Ohio Museum Complex HVAC
Lin Hall, The Ridges – Ohio University
Athens, Ohio

ADDENDUM 02

Addendum to the drawings and specifications for: **Ohio Museum Complex HVAC**

H3.1

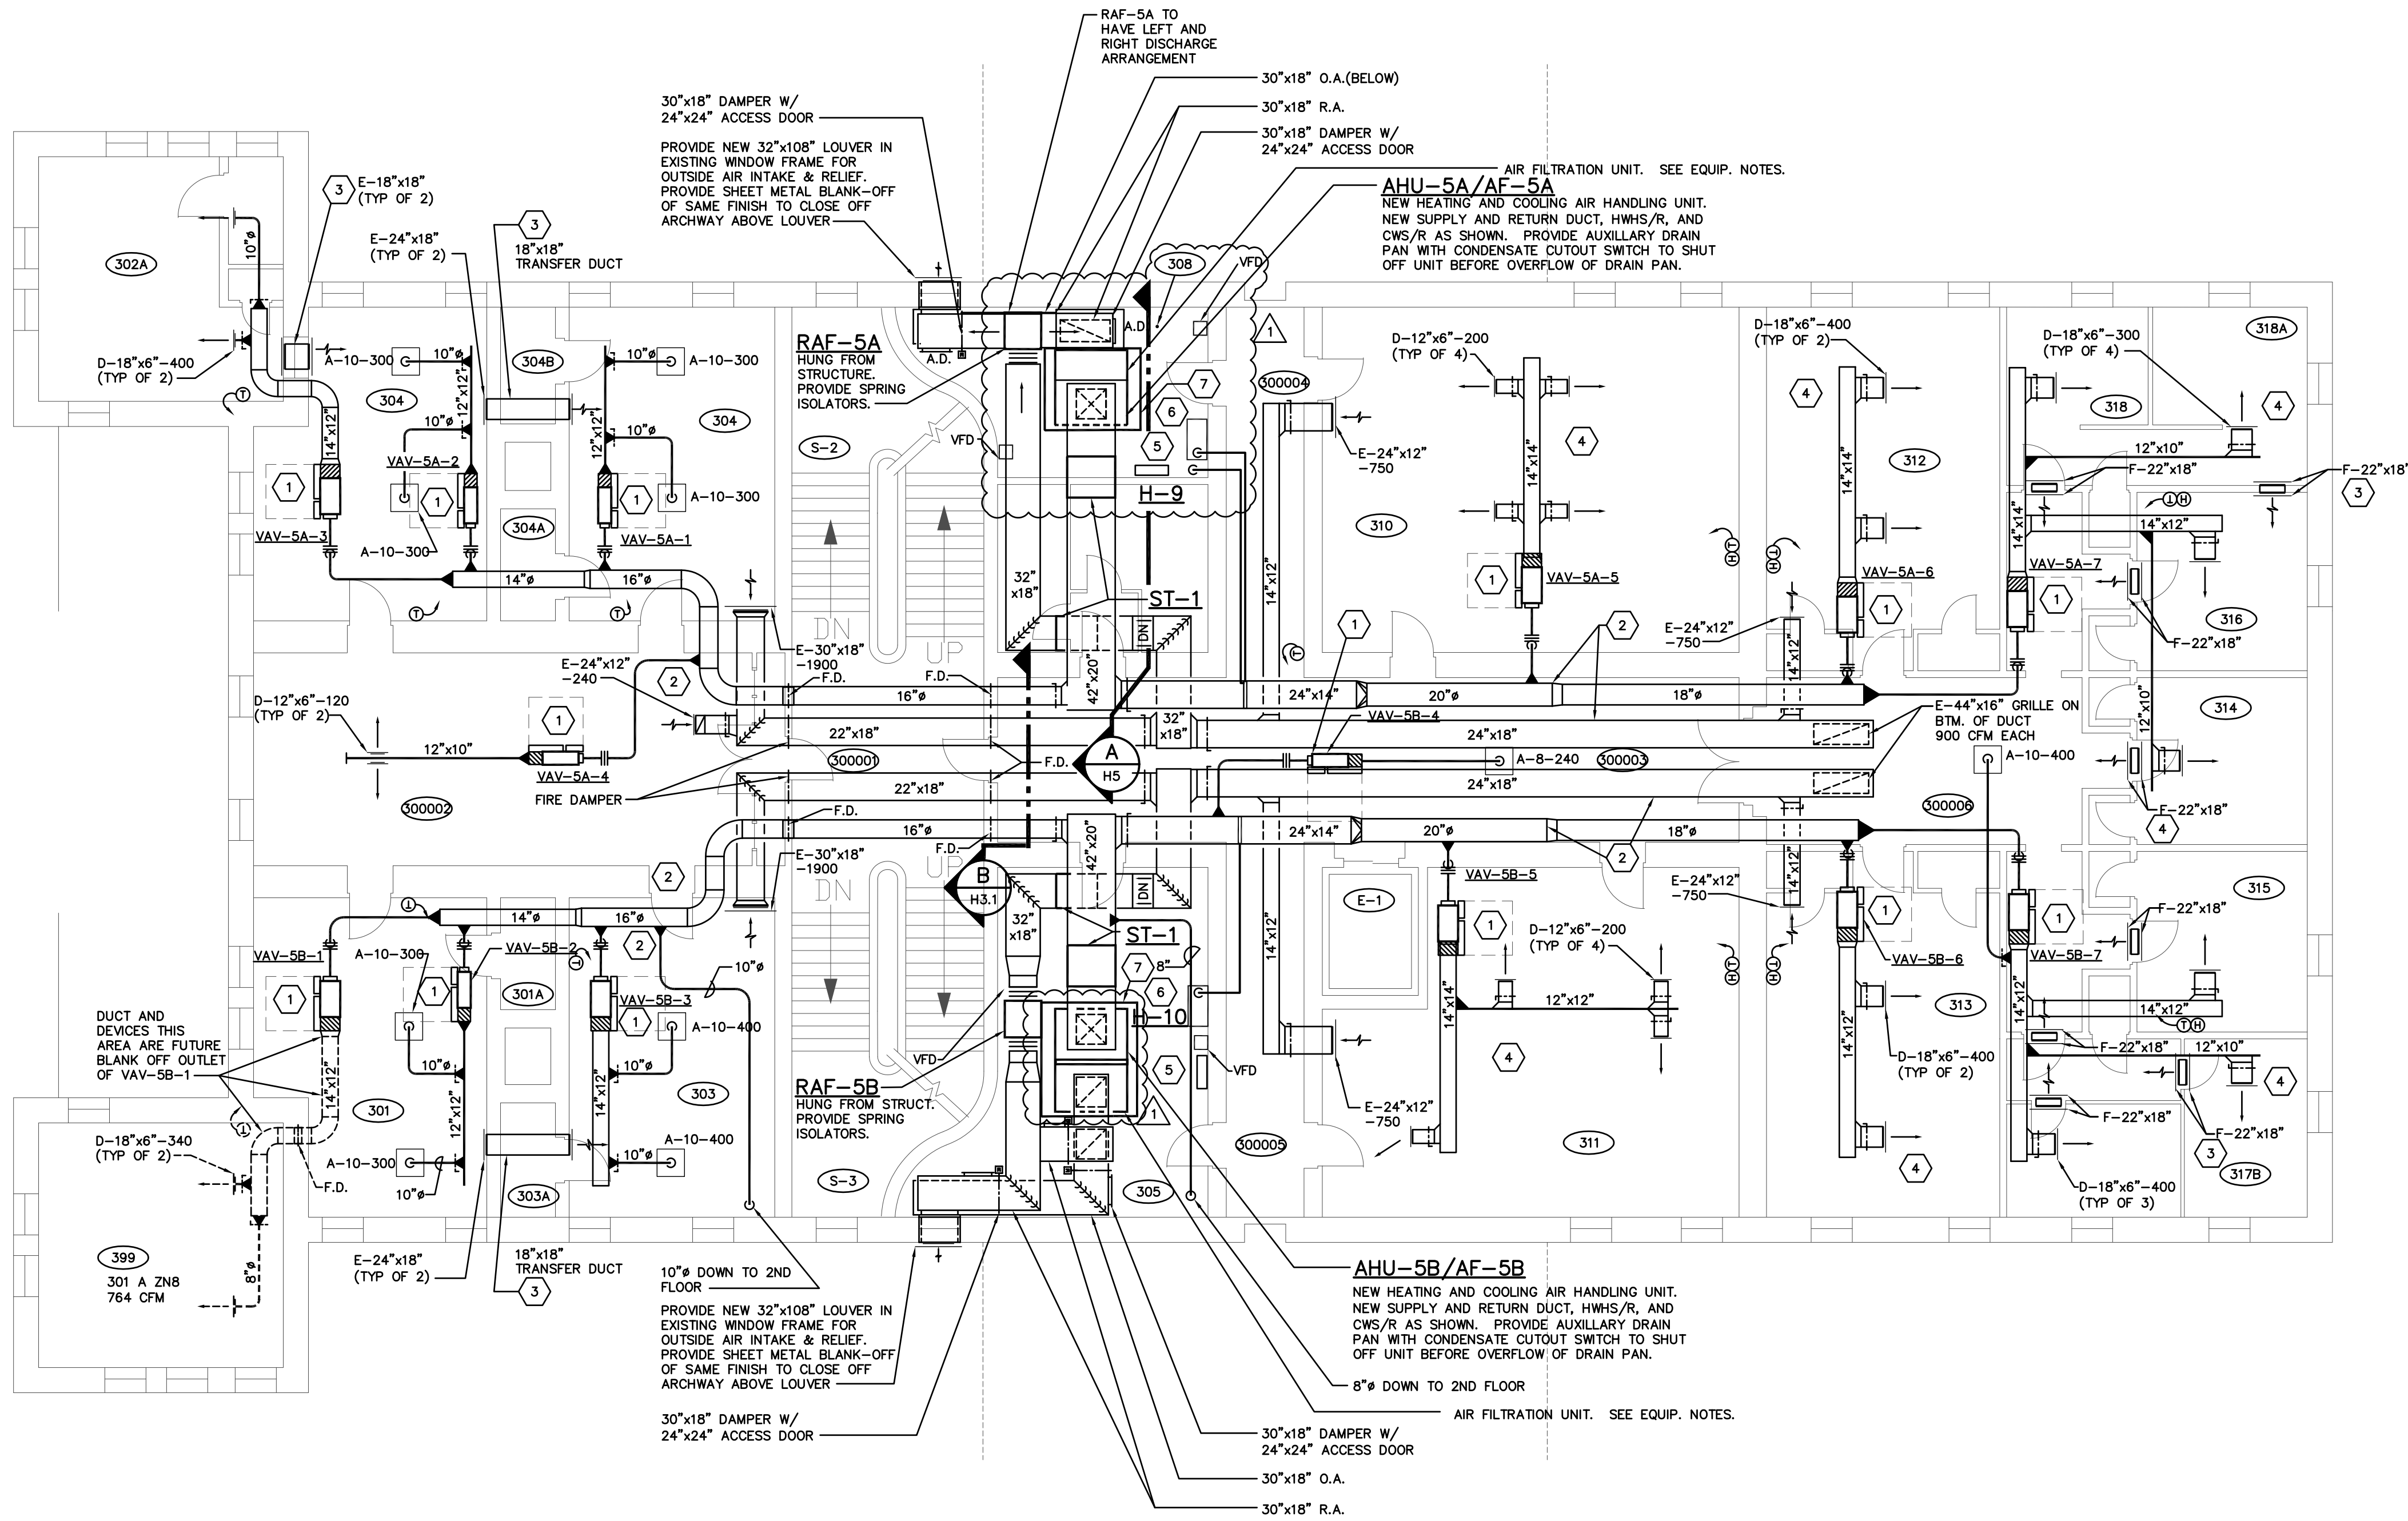
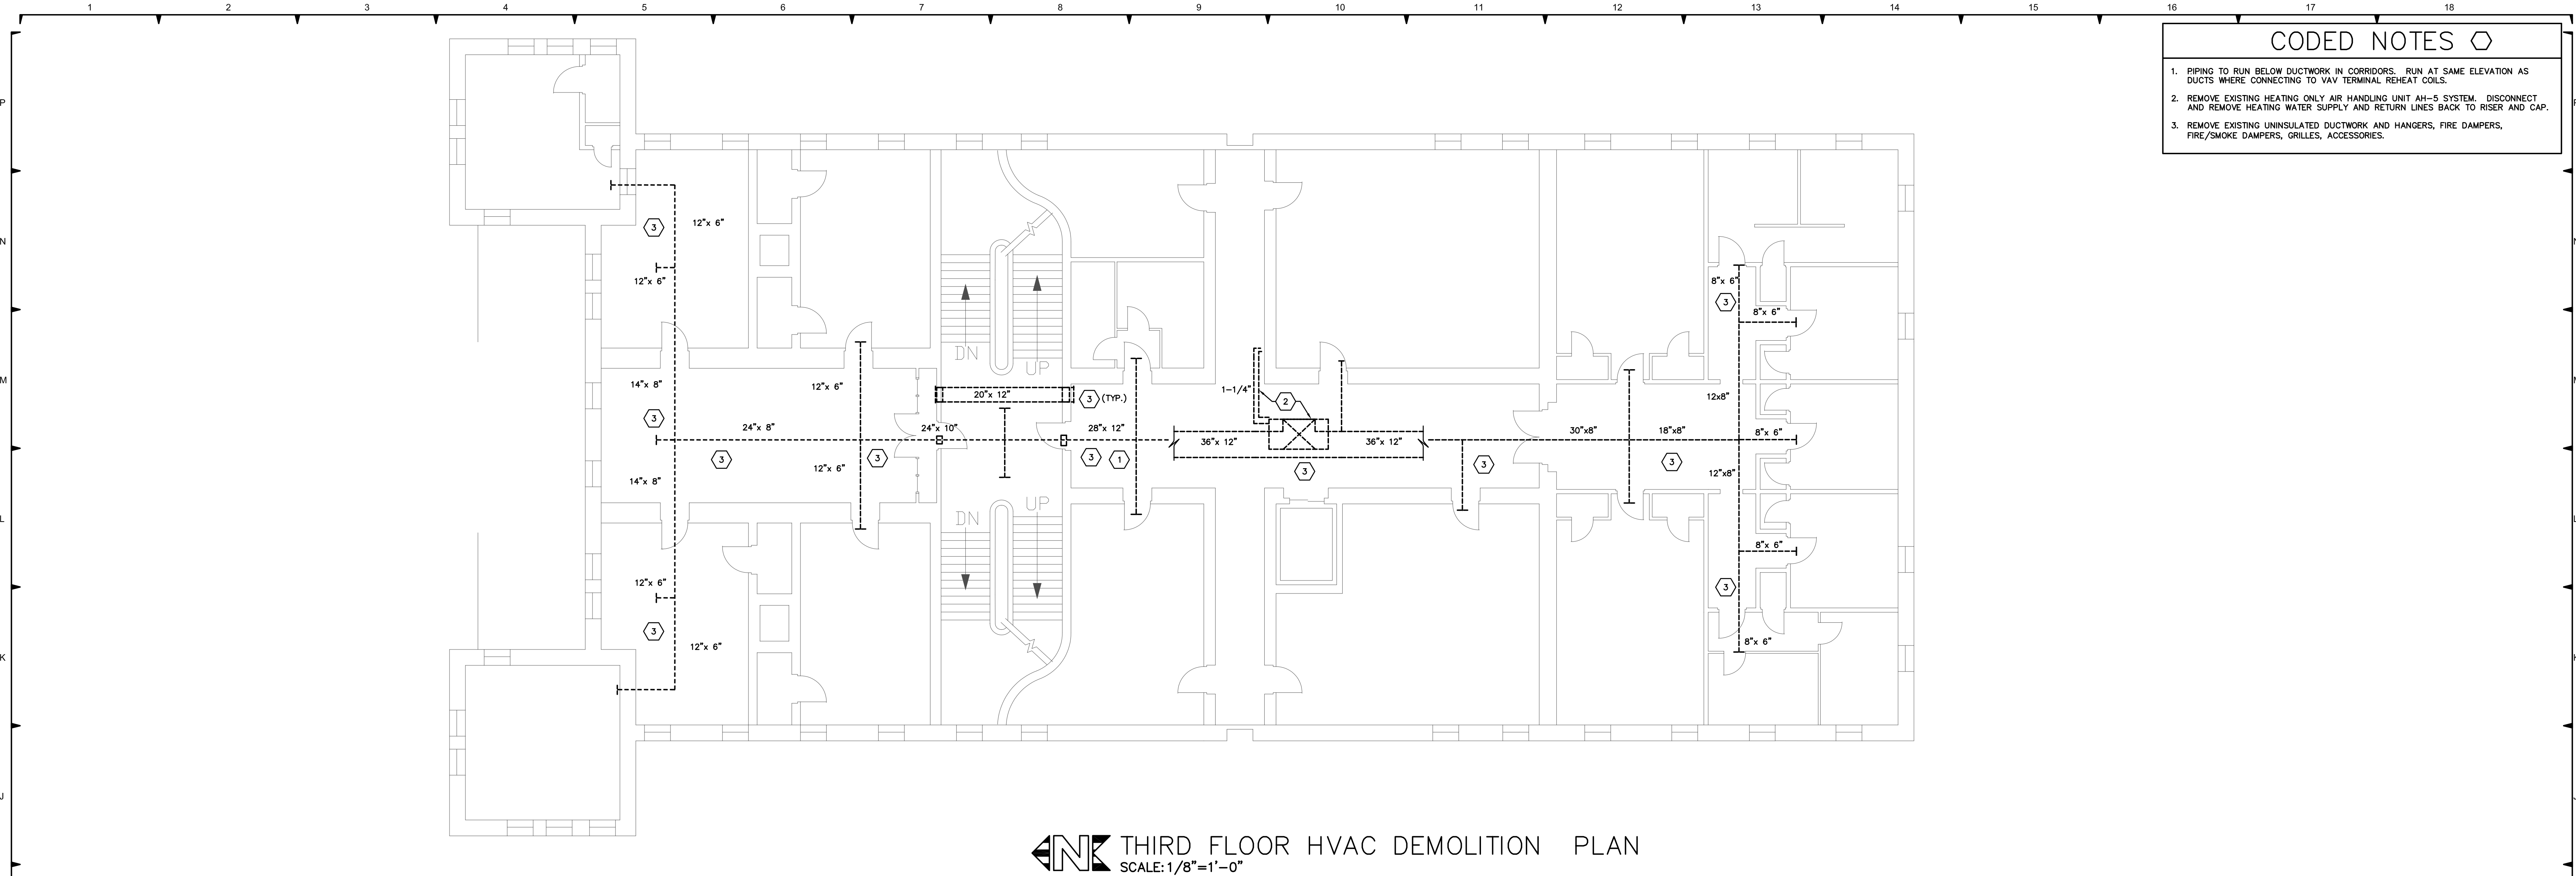
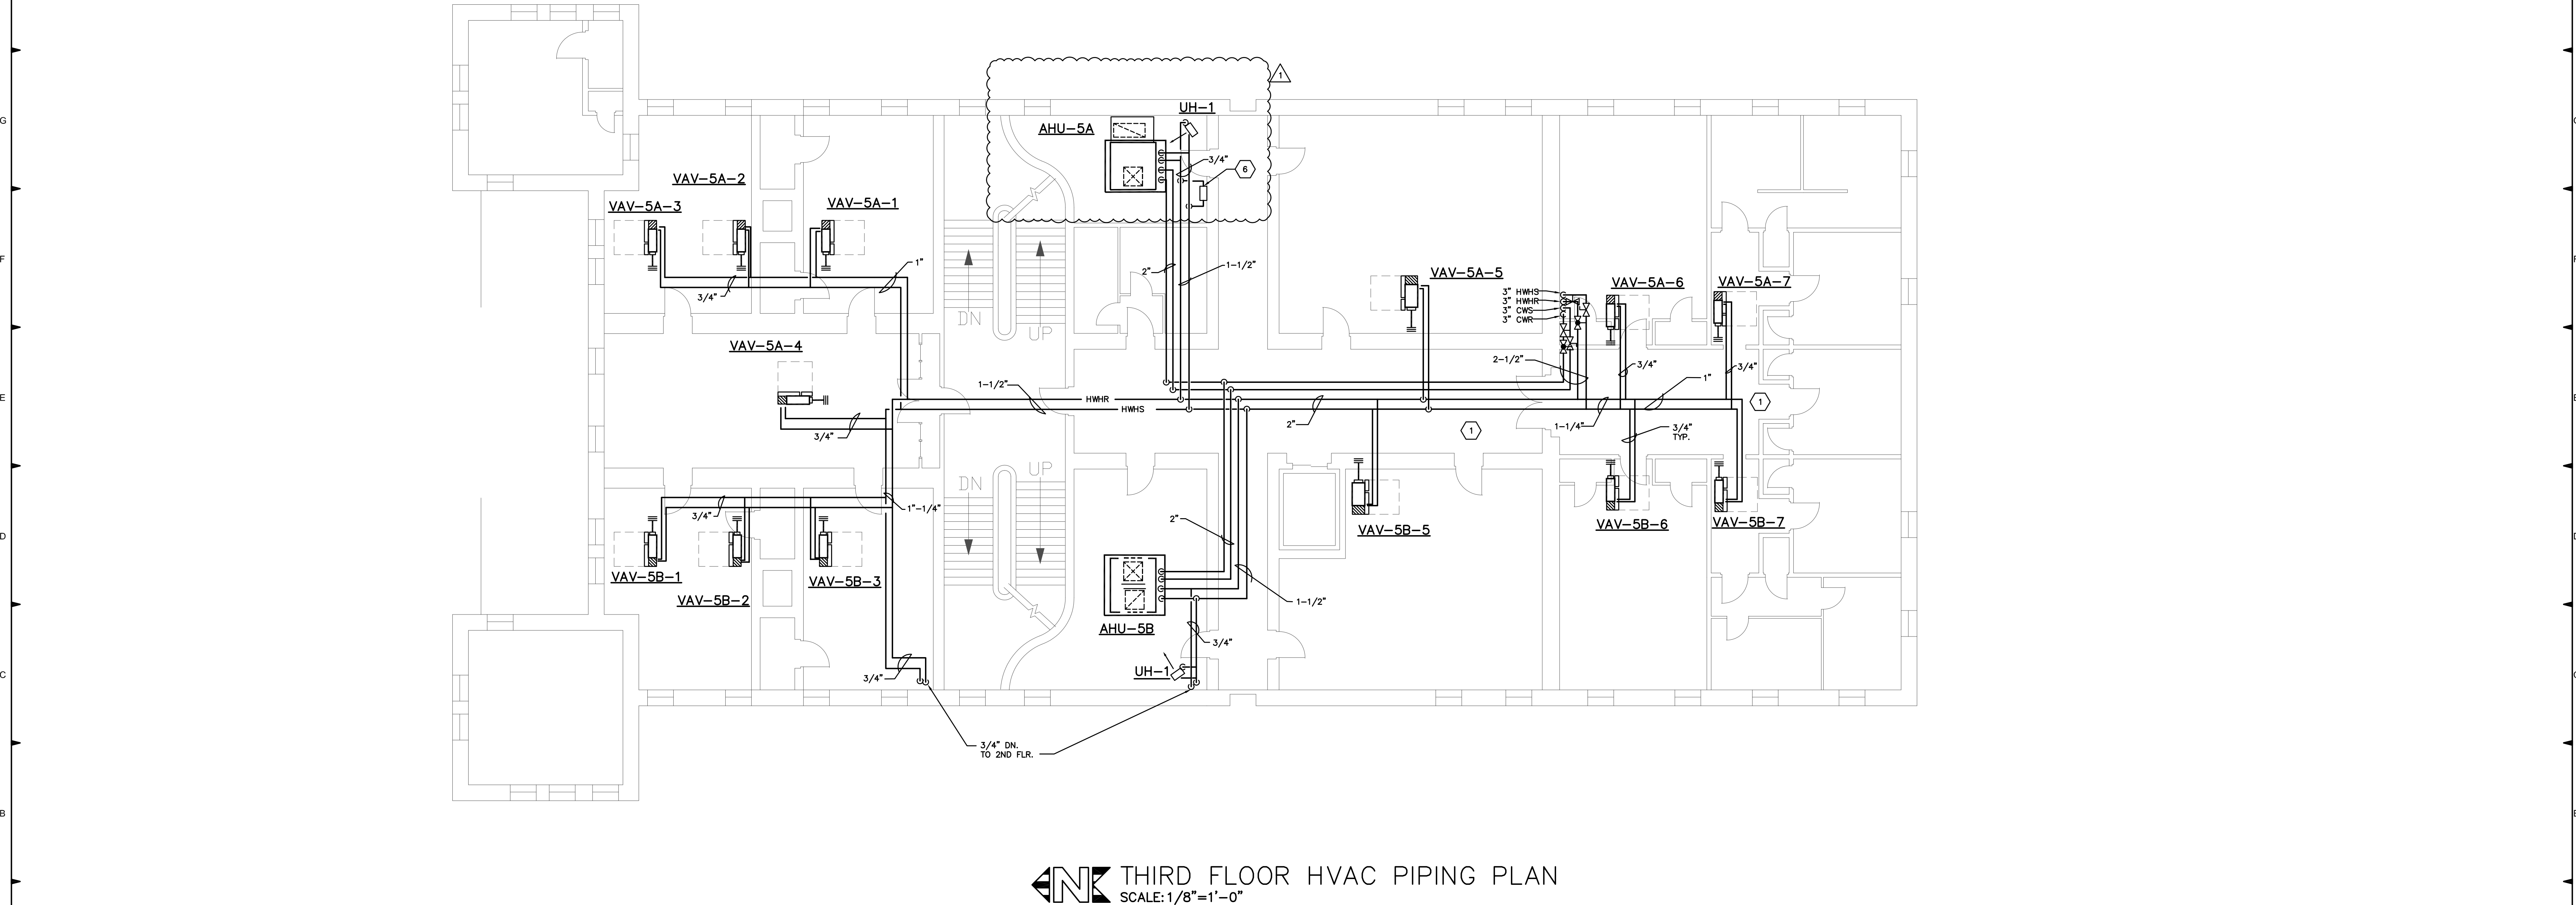
- 6. Sheet H2**
Removed all fin tube radiation.
- 7. Sheet H3.1**
Relocated AHU-5A and RAF-5A to reduce size of mechanical room.
Relocated VFDs, Temperature Control Panel and Humidifier unit H-9 in this room.
Added note to install full size drain pan under AHU units and coil piping connections.
